**PLANNED UNIT DEVELOPMENT
STAFF REPORT****Date: January 17, 2008****DEVELOPMENT NAME**

Paul Persons

CONTEMPLATED USEPlanned Unit Development Approval to amend the site plan
of a previously approved Planned Unit Development to
allow an additional parking lot.

SITE PLAN

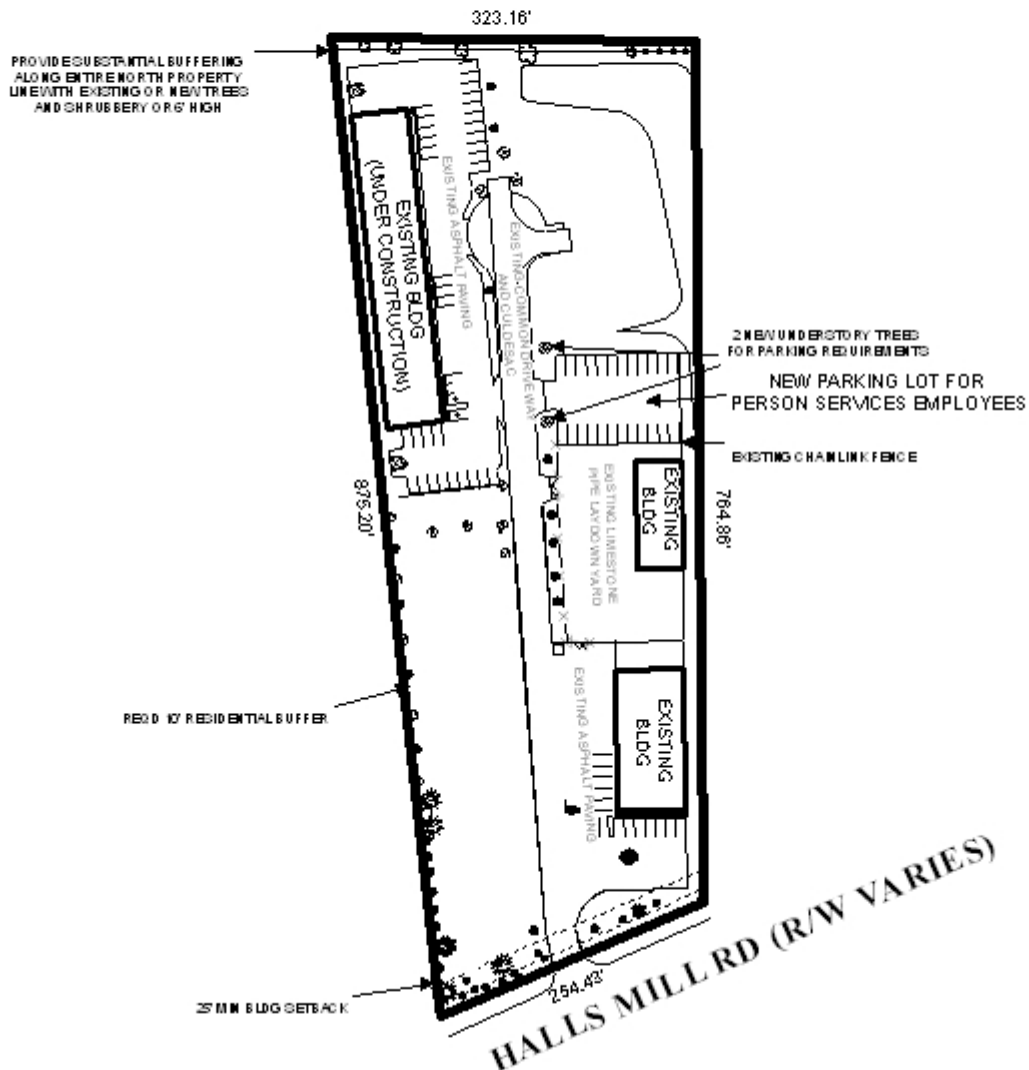
The applicant is proposing to pave a graveled area to provide additional parking for employees. The site plan for the previously approved PUD, from the August 2, 2007 Planning Commission meeting, indicated that the parking area was a limestone-paved pipe lay-down yard. Zoning Inspectors discovered during various site visits that the lay-down yard was also being used for employee parking; limestone paving is not considered an appropriate surfacing material for vehicular parking in B-3 districts, but can be used for material lay-down. The application to amend the PUD was determined necessary when the applicant applied for a land disturbance permit to build a paved parking area.

The existing and proposed parking areas contain more than 10 spaces, thus the parking areas must comply with Section 64-6.A.3.c. of the Zoning Ordinance, *Lighting*, which states that “*if they contain ten (10) or more cars, lighting shall be provided and maintained during their operation, and shall be so arranged that the source of light does not shine directly into adjacent residential properties or into traffic.*”

Planned Unit Development: Based upon the preceding, this application is recommended for Approval, subject to the following condition:

- 1) Full compliance with all municipal codes and ordinances.
